STAFF RECOMMENDATION
901 Gilmore Ave
December 21, 2016

Application: New construction – addition
District: Waverly Belmont Neighborhood Conservation Zoning Overlay
Council District: 17
Map and Parcel Number: 11801029500
Applicant: Kaitlyn Smous
Project Lead: Melissa Sajid, Melissa.sajid@nashville.gov

| <p>Description of Project: The request is for changes to a previously approved addition.</p> <p>Recommendation Summary: Staff recommends approval of the project with the following conditions:</p> <ol style="list-style-type: none">1. Staff shall approve the final selection of the foundation, roof color, doors, and porch railing selections prior to purchase and installation;2. Siding shall be smooth-faced; and3. The skylights shall be flat. <p>With these conditions, Staff finds that the addition meets Sections III for new construction and IV for additions of the <i>Waverly Belmont Neighborhood Conservation Zoning Overlay: Handbook and Design Guidelines</i>.</p> | <p>Attachments A: Photographs B: Site Plan C: Elevations</p> |

Figure 1: 901 Gilmore Ave

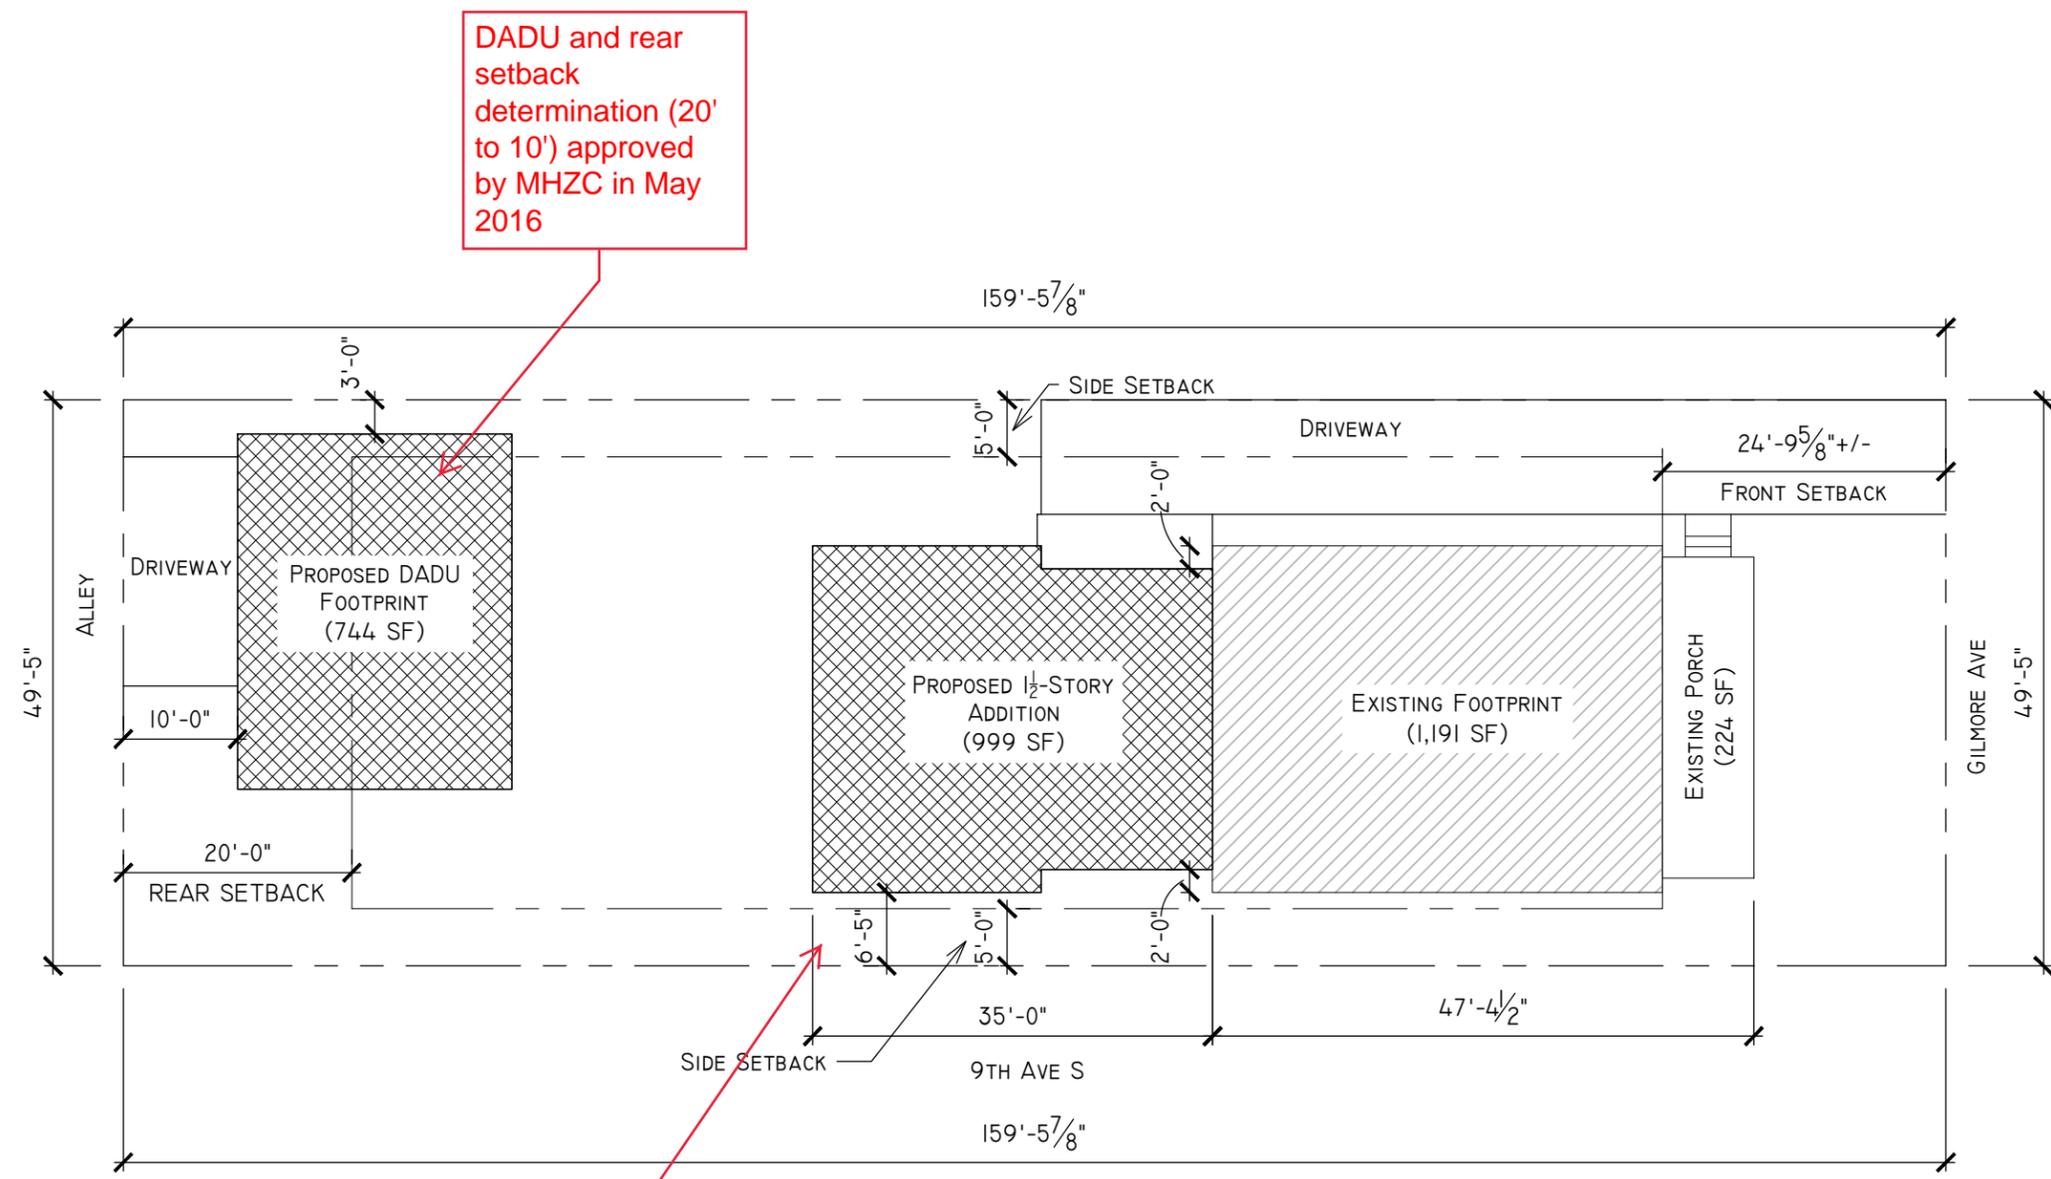
Background: The house located at 901 Gilmore Avenue is a c. 1930 bungalow and contributes to the character of the Waverly-Belmont neighborhood. In May 2016, the Commission approved demolition of a non-contributing rear addition, alterations and repairs to the historic house, a rear addition, and a detached accessory dwelling unit. The May 2016 approval included a side setback determination of six feet, five inches (6'-5") for the rear addition. This application proposes changes to the previously approved addition.

Analysis and Findings: The application is to construct a rear addition that is different from the previously approved addition.

SITE
PLAN

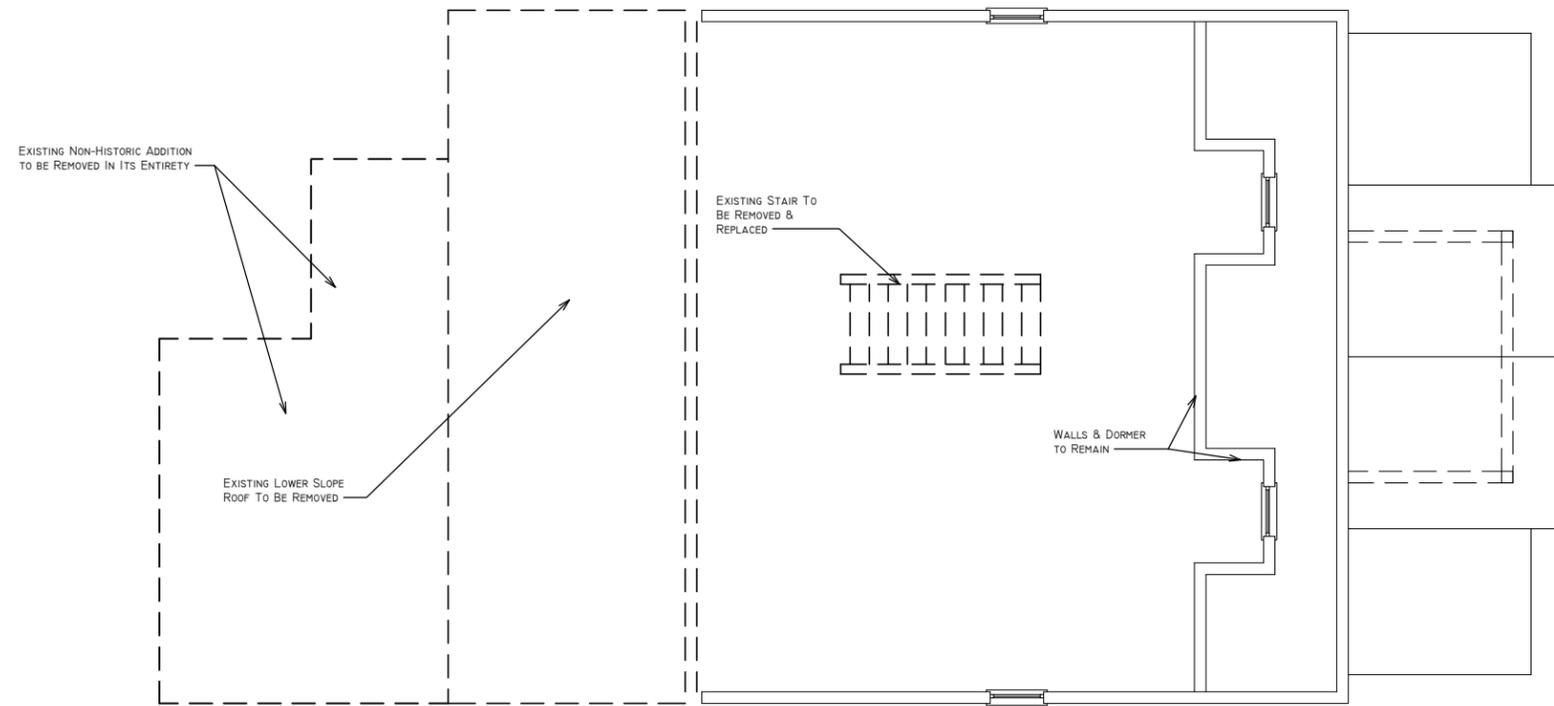
Setbacks: The new addition meets all setbacks required by the base zoning except for the left side setback, which meets the side setback determination of six feet, five inches (6'-5") that the Commission approved in May 2016. The addition is located approximately fifty-eight feet (58') from the rear property line and twelve feet (12') from the right side property line. Therefore, staff finds that the project meets Section III.C for setbacks.

FLOOR PLANS

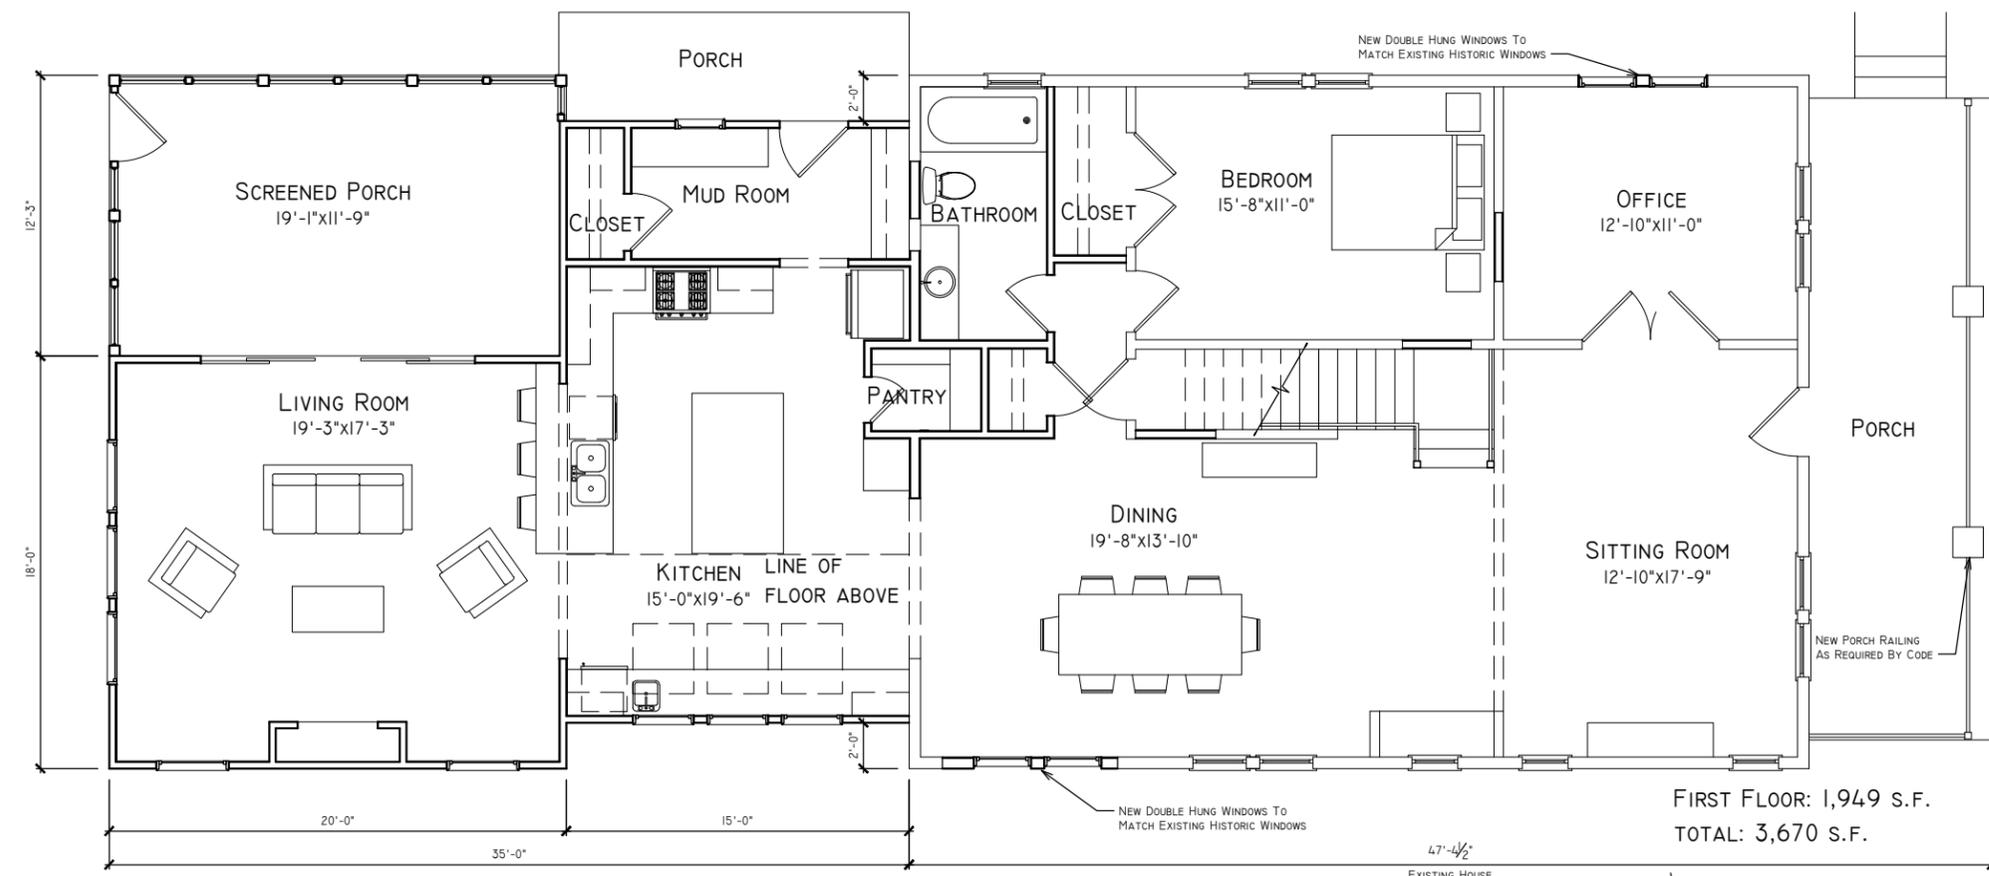
Height & Scale: The proposed additional rear footprint is approximately six hundred fifty-six square feet (656 sq. ft.), compared to the existing footprint which is approximately one thousand, five hundred and thirty-four square feet (1534 sq. ft.). The plan includes the demolition of a three hundred forty-three square feet (343 sq. ft.) non-contributing rear addition that the Commission approved in May 2016. The new addition does not more than double the footprint and adds twenty-two feet (22') to the depth of the

house as the non-contributing rear addition that is to be removed is thirteen feet (13') deep. The new construction is located at the rear and the footprint of the new addition is no wider than the historic house, in accordance with design guidelines.

Design, Location & Removability: The new construction is located at the rear of the historic house, in accordance with design guidelines and meets the design guideline that requires the construction to be inset one foot (1') per story from the rear corners of the historic house. As proposed, the one and one-half story addition sets in two feet (2') from both rear corners of the historic house and goes back approximately fourteen feet, six inches (14'-6") before coming back out to be flush with the historic house.
